# ADDENDUM:

Revised design

July 2023

## CA1 SITE PLAN

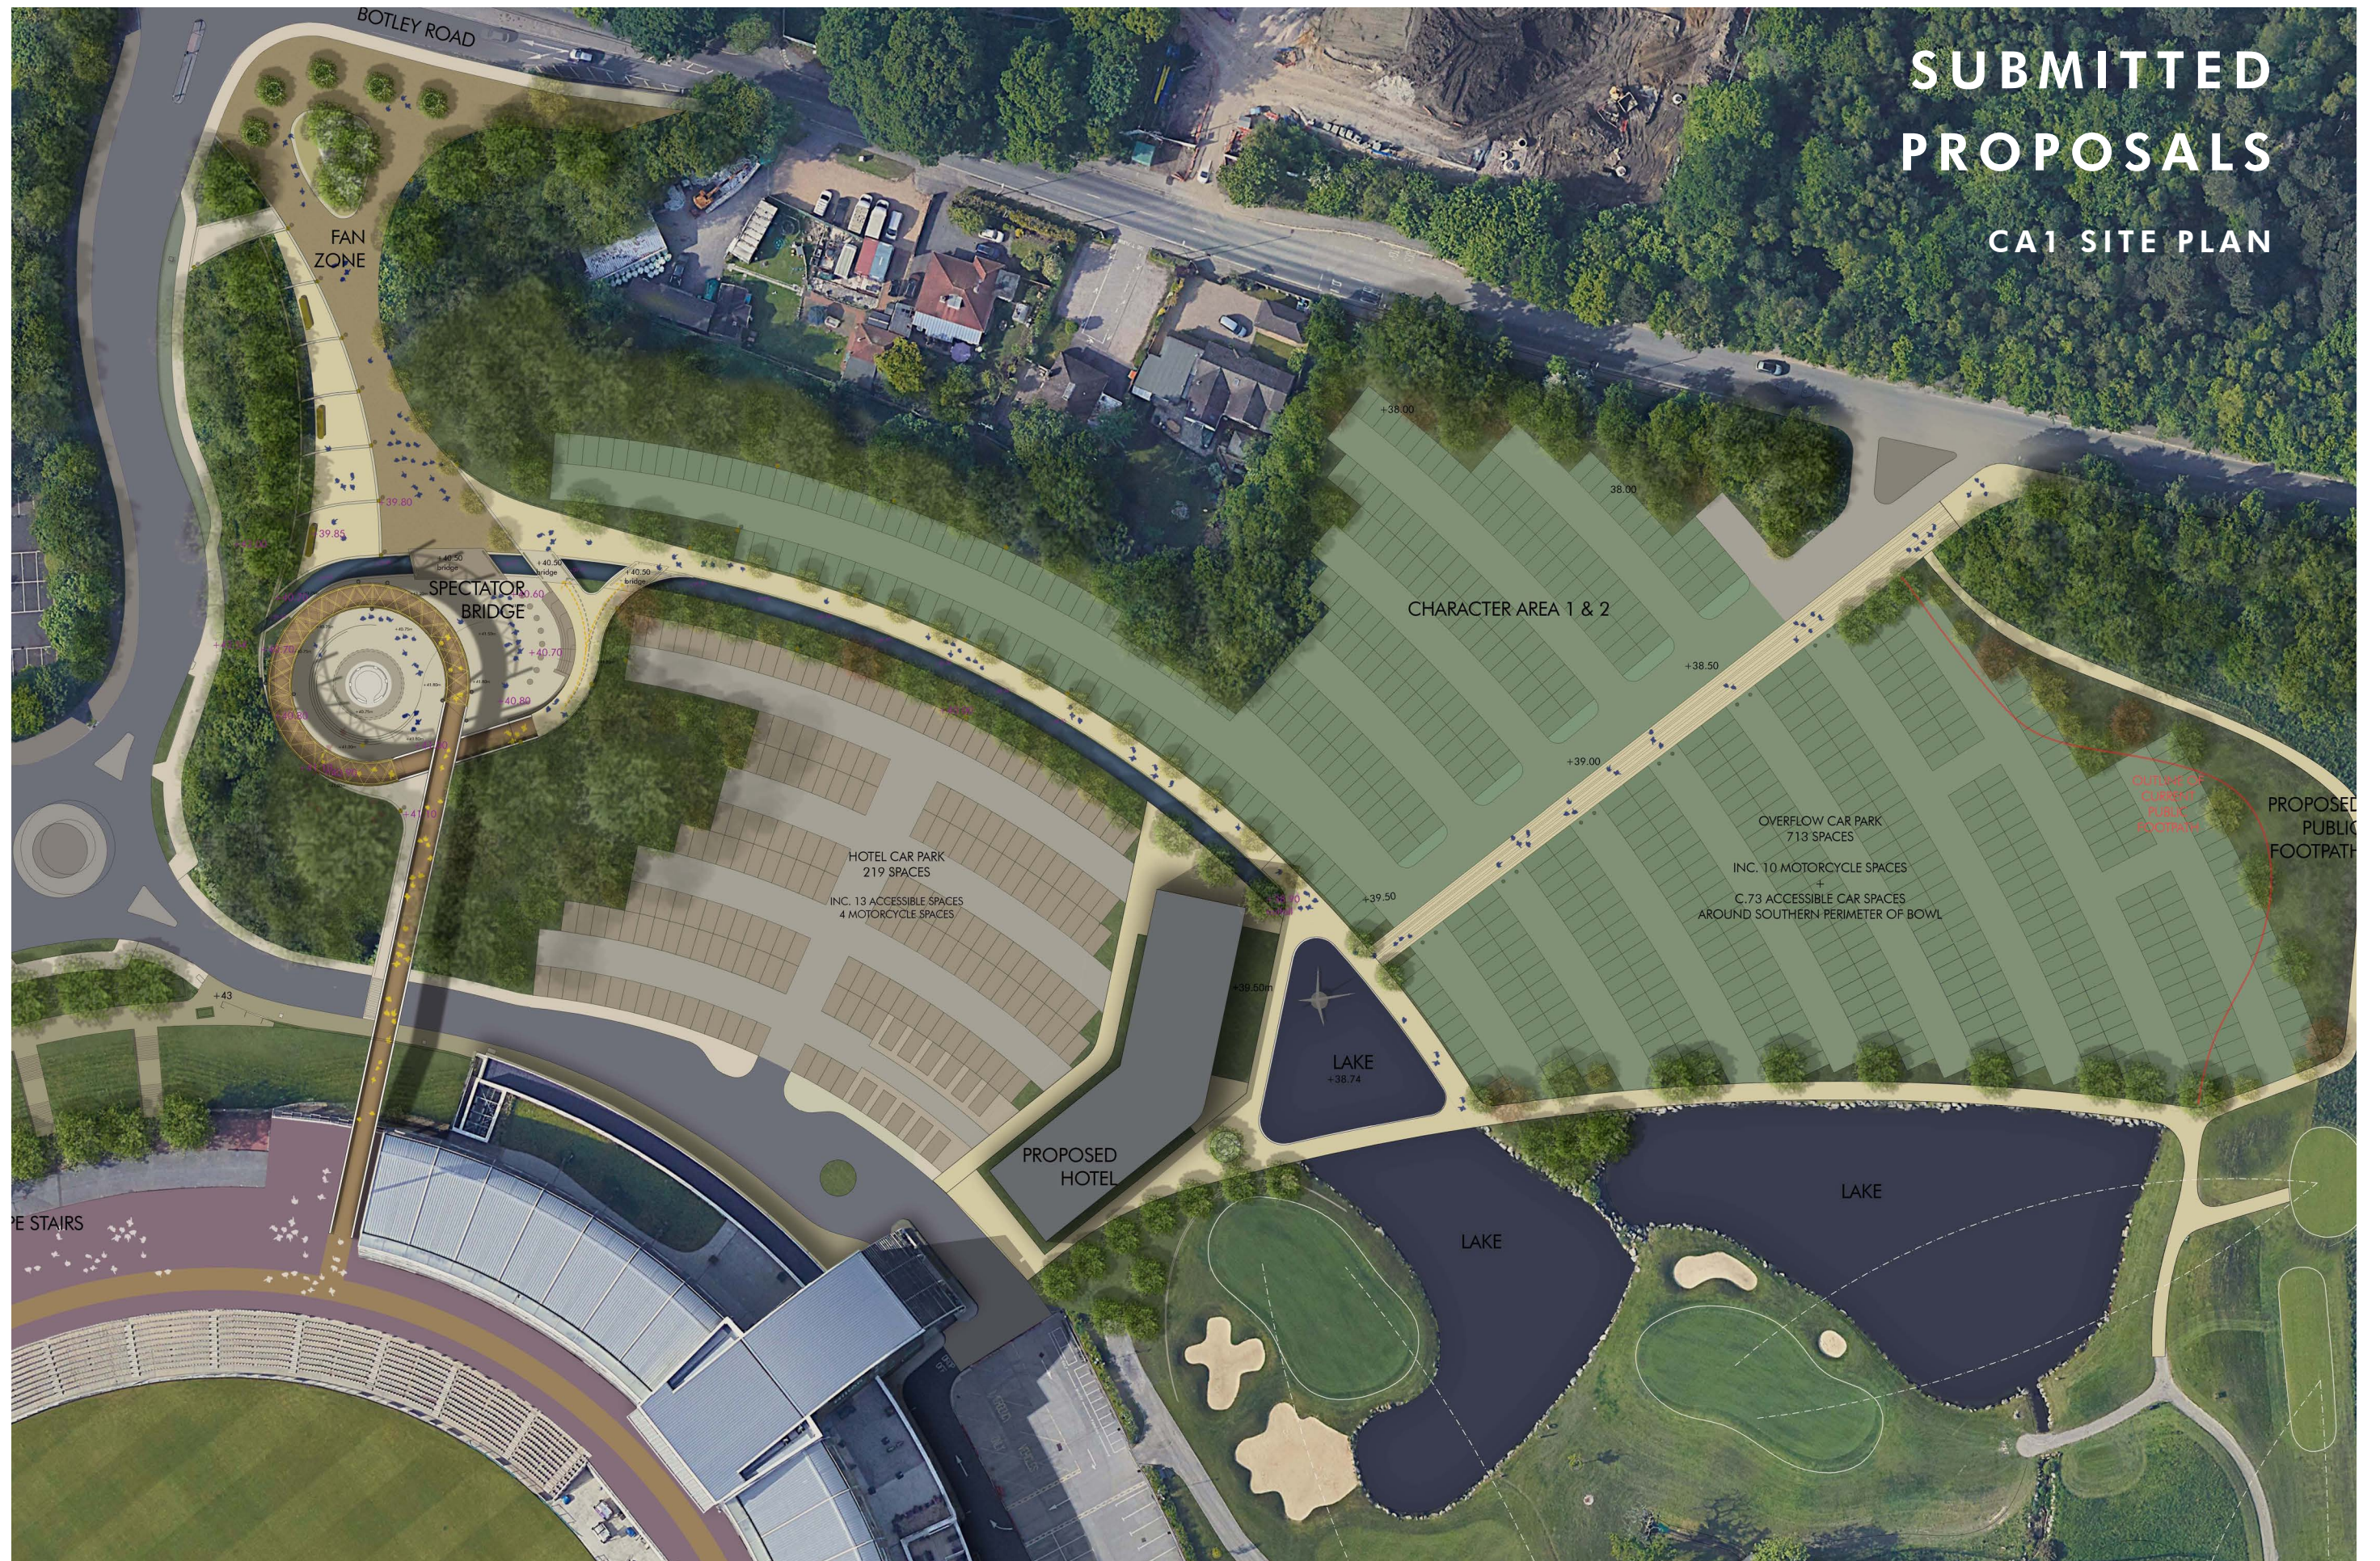
Following wide consultation with numerous stakeholders during the determination period resulted in a number of design changes of which key elements of note are:

- New car parking to north revised to protect and enhance existing mature trees
- Ramp removed and car parking to the west retained to protect and enhance existing trees between car park and adjacent residential properties
- New western car park punctuated by random tree clusters
- Existing drainage landscape enhanced
- Base of hotel softened and bin/bike store added
